**REMARKS**

Application No.: 10/700,481  
Art Unit: 2877

Docket No.: 967.43262X00  
Page 12

FIG. 1  
 Prior Art

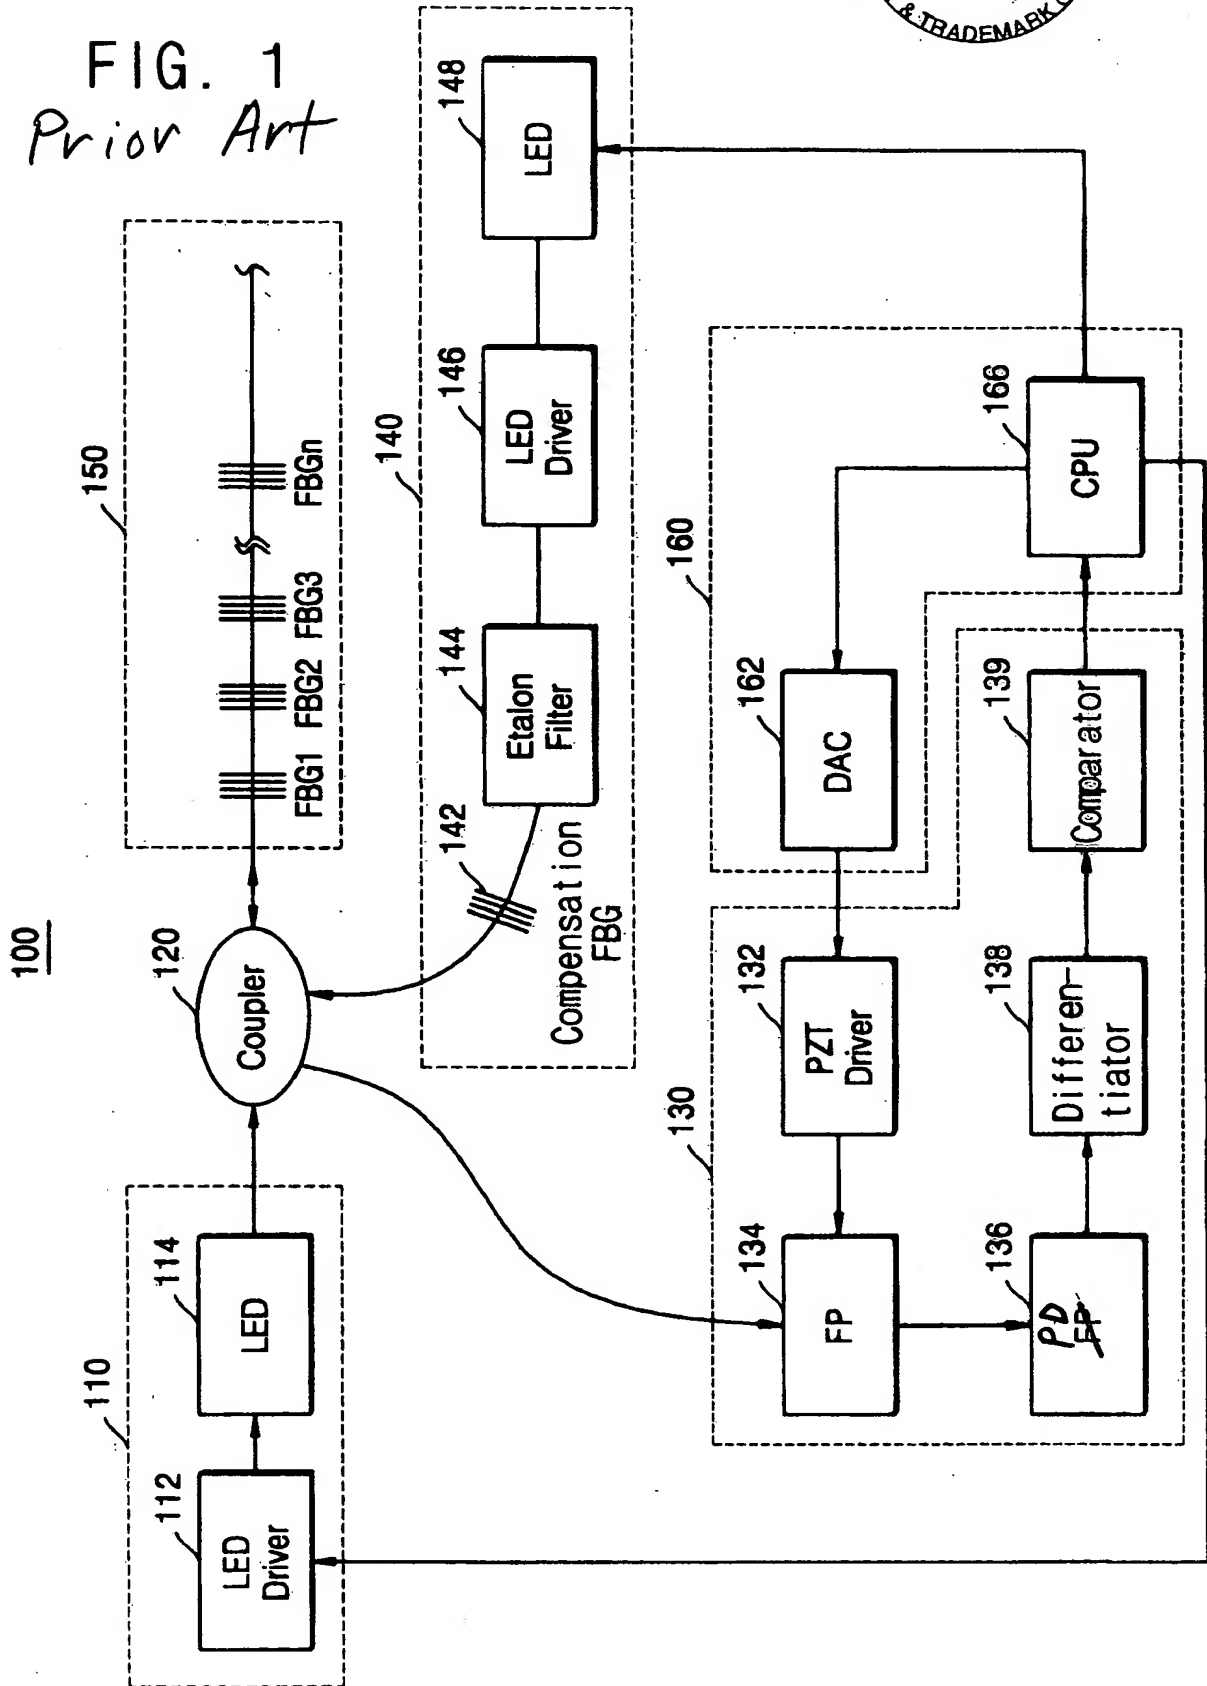
The attached sheets of drawing include changes to Figs. 1 and 2. These sheets, which include Figs. 1 and 2, replace the original sheets including Figs. 1 and 2. Both Figs. 1 and 2 have now been labeled as Prior Art, as required in the Office Action. Also, Fig. 1 has been amended to correct the labeling of Box 136 to indicate that this is a photo diode (PD) corresponding, for example, to the identification of the element 136 as a Photo Diode (PD) on page 2, line 19 of the specification. It is assumed that this is the element which was actually intended by the Office Action statement "the drawings are objected to because the element "EP" 130 in Fig. 1 should be changed to "PD."" With regard to this, it does not appear that there is actually any element labeled "EP" 130 in Fig. 1. Accordingly, it is Applicants' understanding that the element 136, previously labeled "FP" is what was actually intended on page 3, lines 1 and 2 of the Office Action.
